HISTORIC AND DESIGN REVIEW COMMISSION

February 15, 2017

HDRC CASE NO: 2017-048
ADDRESS: 146 E HOUSTON ST
LEGAL DESCRIPTION: NCB 404 BLK 20 LOT W IRR 3.81'X18.09' OF 11 & 12 HOTEL VALENCIA
SAN ANTONIO RIVERWALK
ZONING: D,HS
CITY COUNCIL DIST.: 1
LANDMARK: Maverick Building
APPLICANT: Christina Garcia/Aetna Sign Group
OWNER: Acenar Mexican Restaurant
TYPE OF WORK: Signage, pedestrian menu board installation
REQUEST:

CUSTOMER:	Acenar Mexican Restaurant	DRAWING#:	3054.1
ADDRESS:	146 E Houston St	SALES REP:	Cesley G.
CITY:	San Antonio, Texas	DESIGNER:	Arnie V.
DATE:	4-6-16	CLIENT APPROVAL:	
COMPUTER FILE:	art/dwg/misc/3054_acenar	TSCL#	1837D
REVISION HISTORY:	4-6-16, 4-25-16, 11-14-16

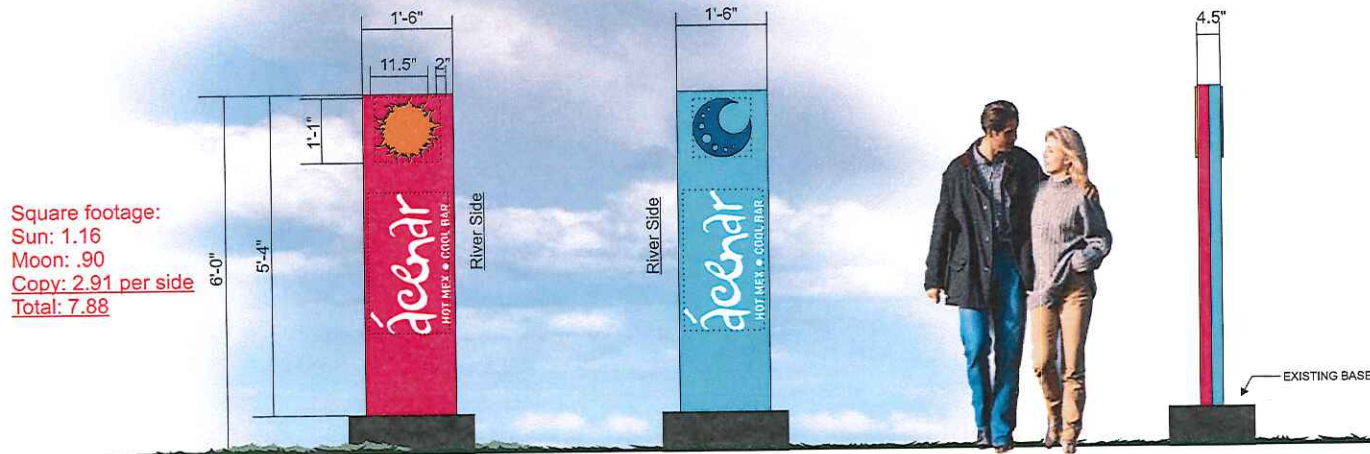
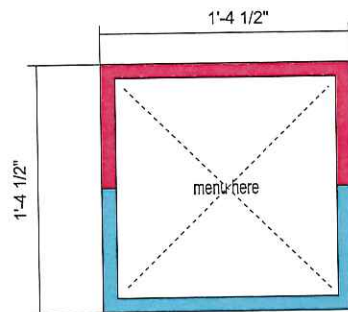
- b. Per the UDC Section 35-681, signage on the riverside of properties shall not exceed eight (8) square feet. Per the Code of Ordinances, Chapter 28, Section 6, a sign’s area consists of the entire advertising area of a sign excluding any framing, trim or molding and the supporting structure. The applicant has proposed a total square footage of sixteen (16) square feet, including both sides of the proposed sign. This is not consistent with the UDC Section 35-681(c)(2).

Staff does not recommend approval of item #1 based on finding b. Staff recommends the applicant reduce the overall square footage of the proposed sign to no more than eight (8) total square feet.

CLIENT:	Acenar Mexican Restaurant	DRWG#:	3054.2
ADDRESS:	146 E Houston St	SALES REP:	Cesley G.
CITY:	San Antonio, Texas	DESIGNER:	Arnie V.
DATE:	11-14-16	CLIENT APPROVAL:	
COMPUTER FILE: ar\dwrg\misc\3054_acenar			TSC#18370
REVISION HISTORY:

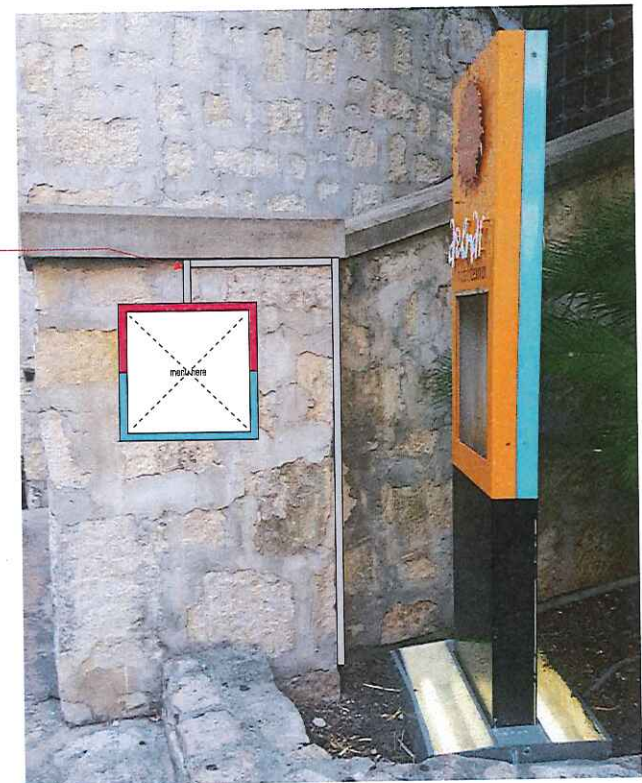
- c. On an existing stone wall, the applicant has proposed to mount a pedestrian menu board. The proposed menu board is to be 1’ – 4 ½” in height and width for a total of approximately 7.9 square feet. The proposed menu board will feature an internal light to illuminate the menu. The proposed menu board is consistent with the UDC Section 35-681(a)(8).

Staff recommends approval of item #2 based on finding c.
